Amendment No. 4

All Bidders shall make the following changes to the bid book:

City of Bath
Front and Elm Street Streetscape;
And Water Street Mill and Fill

ELM & FRONT STREET RENOVATION
BATH, MAINE

D100

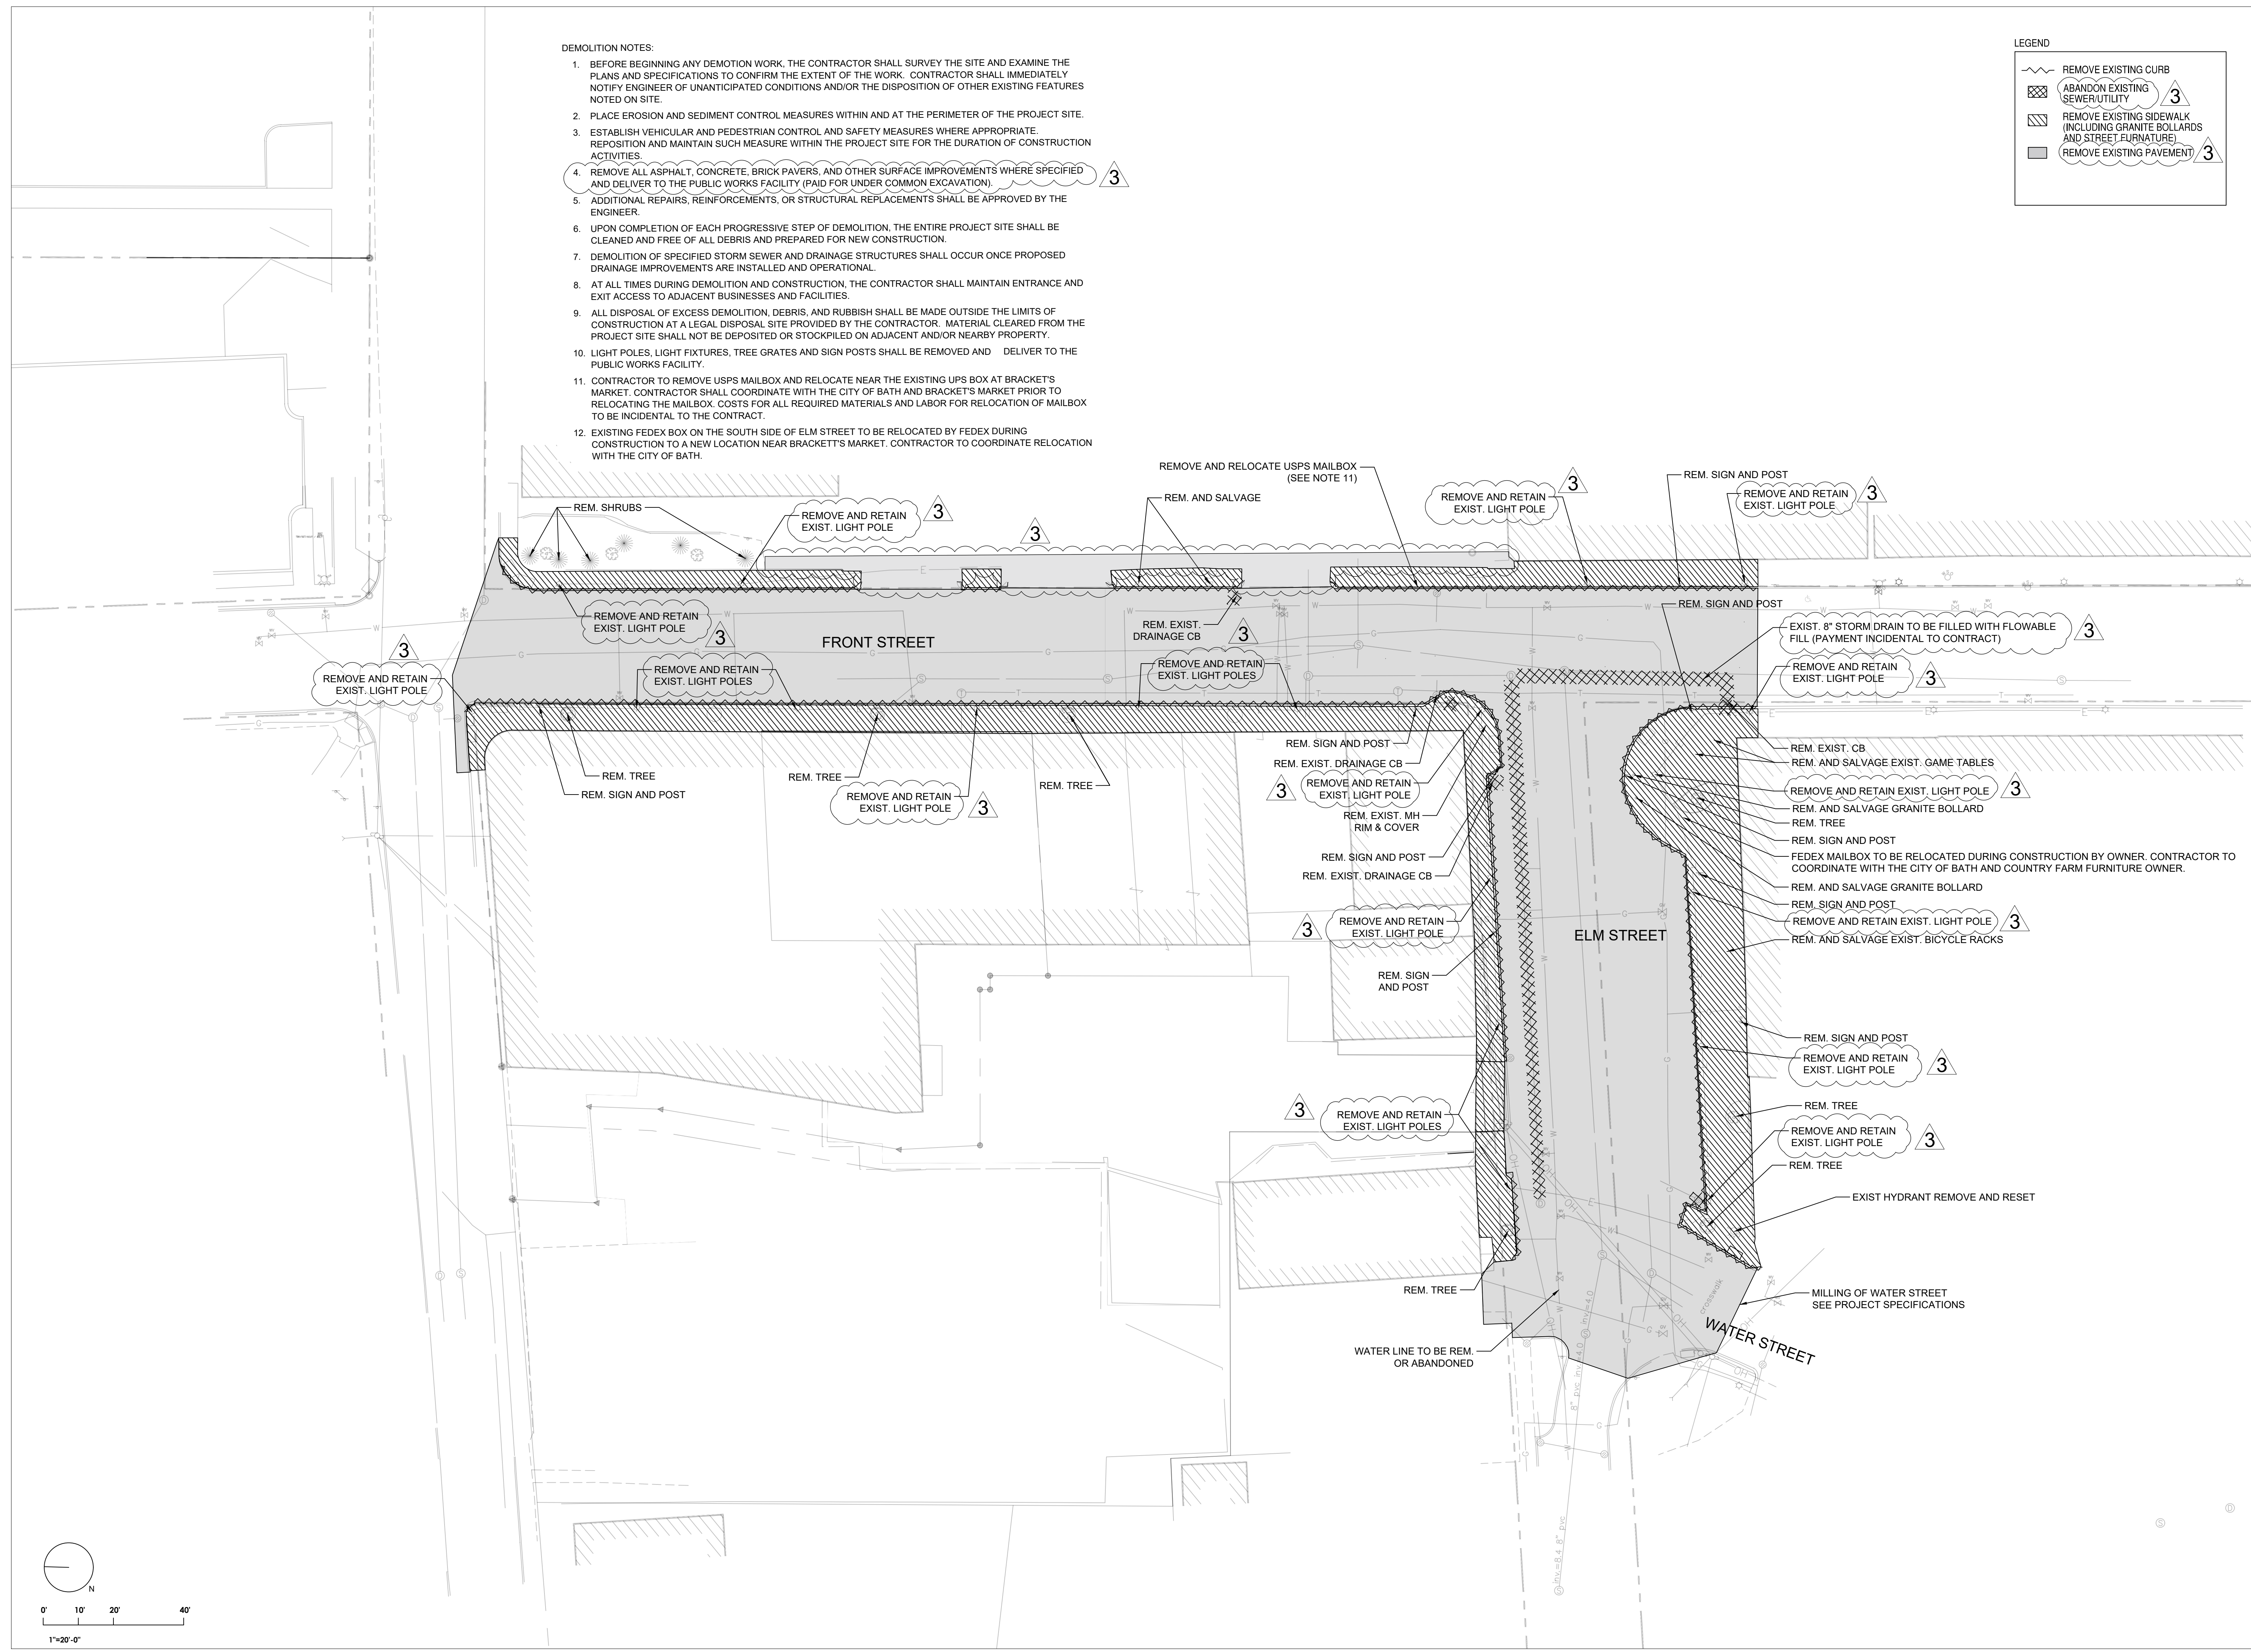
Question: Please clarify scope of pavement installation on Elm Street/Front Street. It is clear that Water Street is a mill and fill, but currently Front/Elm shows milling on the demolition plan D100, but the materials plan shows Asphalt per detail DT1/C100, which is 4" of mix over gravel.

Response: The milling term was used incorrectly on the demolition plan. The notes should have indicated that the pavement would be removed. See revised Demolition plan (attached). The intent is that all pavement on Front and Elm Streets be removed. Excavation will occur down to the bottom of the proposed subbase layer. The ground will be reshaped to accommodate the proposed grading as shown on the grading plan. Then 18" of Aggregate Subbase – Course Gravel (Item 304.10) will be installed, followed by 2" of base pavement (12.5mm Hot Mix Asphalt – Item 403.2131) and 2" of surface pavement (12.5mm Hot Mix Asphalt – Item 403.2081). The Special Provision 403, Hot Mix Asphalt Pavement, in the bid book is correct. Quantities for Aggregate Subbase Course – Gravel have also been

revised. Item 202.202 – Removing Pavement Surface has been removed from the Front and Elm Street Streetscape Segment. The existing pavement in that area will be removed under the Common Excavation item. An error was also found in the wording for item 206.07. The work “earth” has been revised to “rock” to match the MaineDOT standard specifications for that item. The Schedule of Items has been updated to account for all of the changes noted above.

4. REMOVE ALL ASPHALT, CONCRETE, BRICK PAVERS, AND OTHER SURFACE IMPROVEMENTS WHERE SPECIFIED AND DELIVER TO THE PUBLIC WORKS FACILITY (PAID FOR UNDER COMMON EXCAVATION) 3

1 NEW LIGHTING POWER PLAN
E300

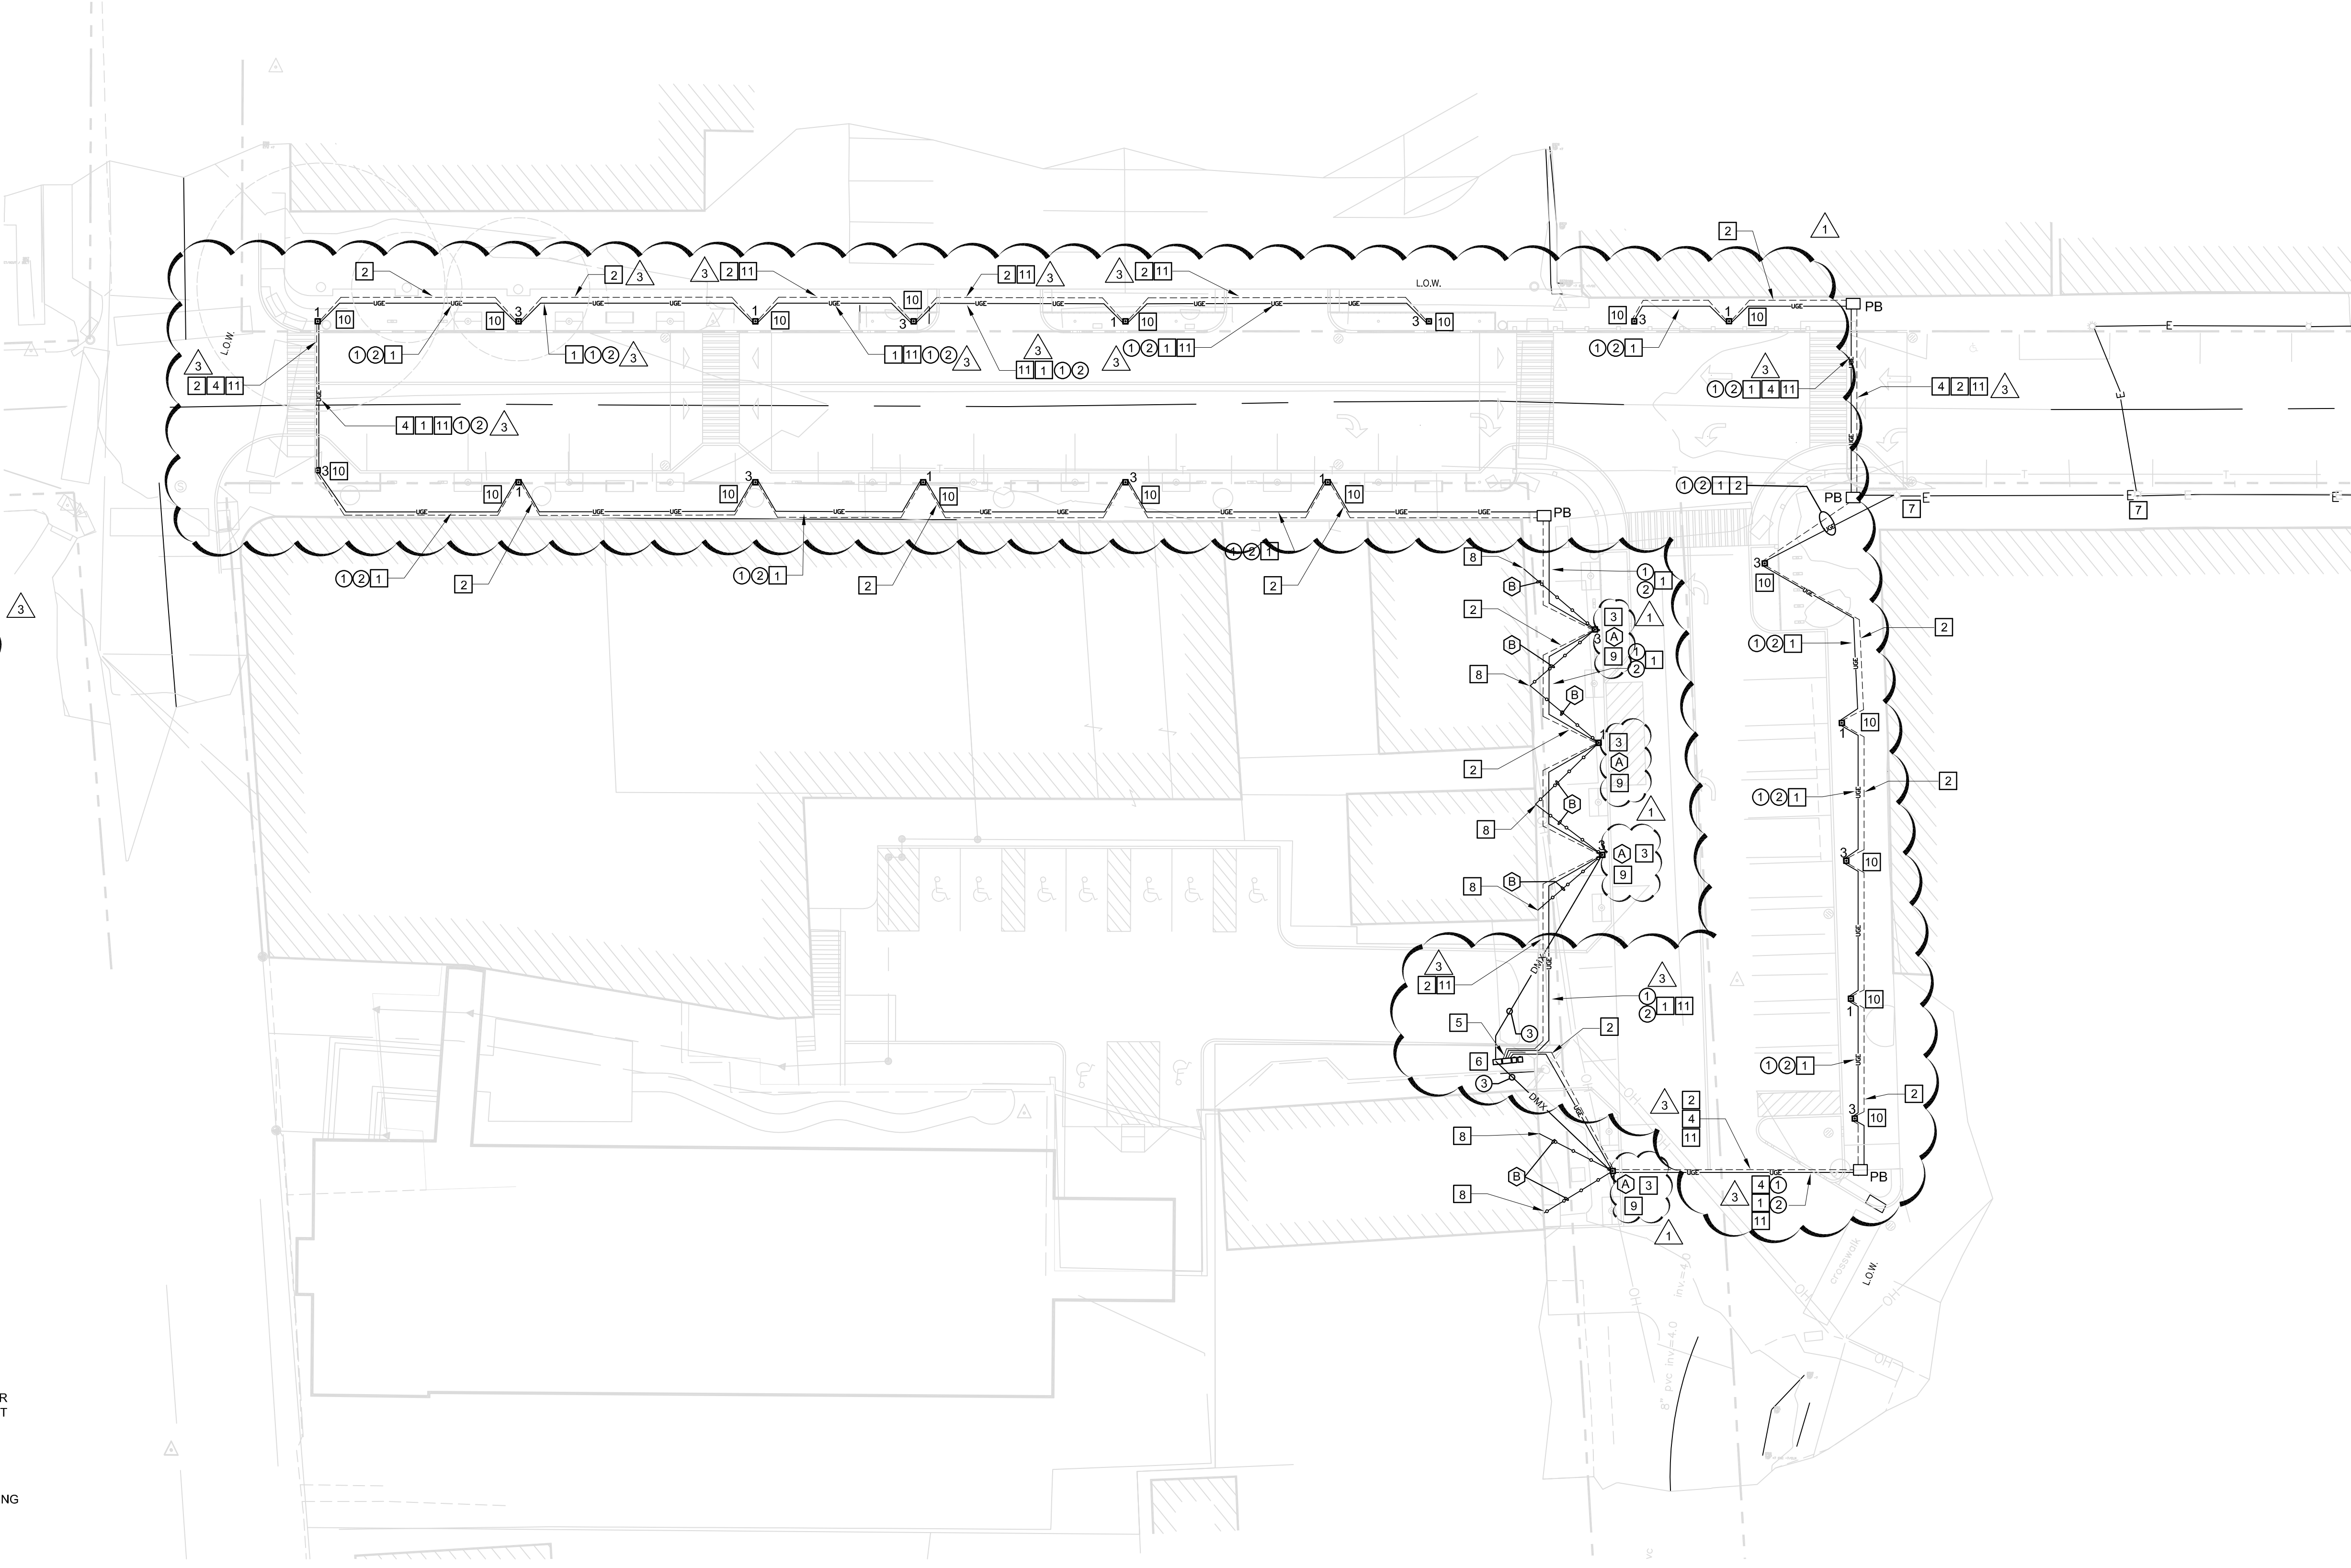
Question: General Note #9 on sheet E300 call for 2" RMC conduit under areas with vehicular traffic, but there is no metallic conduit on the bid sheet. Please clarify if RMC is intended, where, and how it will be paid for.

Response: Amendment 2 answered this question as follows: MaineDOT specifications call out RMC conduit where it is subject to vehicular traffic, or concrete encased if it is PVC. Detail 6/E400 calls out both RMC OR PVC, and shows the PVC concrete encased. The notes on the drawings call out PVC, so under the roadways PVC conduit encased in concrete should be used per 6/E400 (not RMC per note #9). Payment for “Non-Metallic Conduit, Concrete Encased” shall be incidental to the 626.22 Non-Metallic Conduit item already in the Schedule of Items. The concrete encased conduit shall meet the requirements of MaineDOT

This Amendment 4 changes the above to remove the sentence “Payment for “Non-Metallic Conduit, Concrete Encased” shall be incidental to the 626.22 Non-Metallic Conduit item already in the Schedule of Items”. A pay item for Non-Metallic Conduit, Concrete Encased has been added to the Schedule of Items to cover this work and the quantities for both conduit items have been revised to reflect this change. An updated E-300 drawing is also attached which reflects these changes.

9. ALL CONDUIT FOR ROADWAY LIGHTING SHALL BE NON METALLIC CONDUIT (2" SCHEDULE 80 PVC) WHERE NOT SUBJECT TO VEHICULAR TRAFFIC AND NON METALLIC CONDUIT, CONCRETE ENCASED WHERE SUBJECT TO TRAFFIC. ALL CONDUCTORS SHALL BE COPPER WITH TYPE XHHW INSULATION. CONDUCTOR SIZES SHALL MATCH EXISTING LIGHTING CIRCUIT CONDUCTORS.

- 11 NON-METALLIC CONDUIT, CONCRETE ENCASED

- Revisions
- 9.27.24 UPDATED LUMINAIRE INFORMATION
 - 10.29.24 UPDATED NOTE 9. ADDED NON-METALLIC CONDUIT, CONCRETE ENCASED (KEY NOTE 11)
